Access Compliance Report Public Rights-of-Way (RR Crossings)

Intersection ID: 10025402	Main Street: E_BLAND_ST	Location: N/A
ADA ID: 8DAD00B900B1	Overall Compliance: No	Severity Score: 0.0
Codes/Mitigation Info/Possible Solution		Field Measurements/Component Compliance

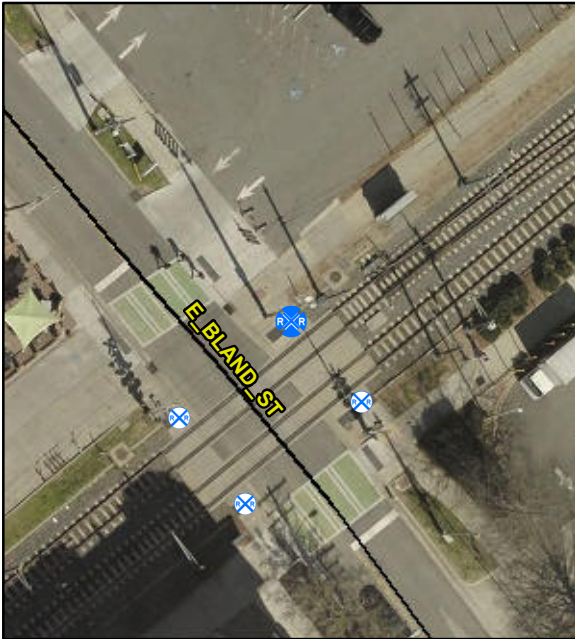
**Remove & Replace Detectable
Warning System. Provide Pedestrian
Gate. Remove & Replace Walking
Surface Adjacent to Rail.**

R302.7.4, R305.2.5

Compliance	Description	Data
Yes	DWS Provided?	Yes
Yes	DWS Contrast?	Yes
Yes	DWS Width (in)	Yes
Yes	DWS Length (in)	36.0
No	DWS Offset (in)	29.0
No	Pedestrian Gate?	No
N/A	DWS Outside Gate?	No
N/A	Rail Type?	LightRail
No	Flangeway Gap (in)	3.0
Yes	Sidewalk Width (in)	81.0
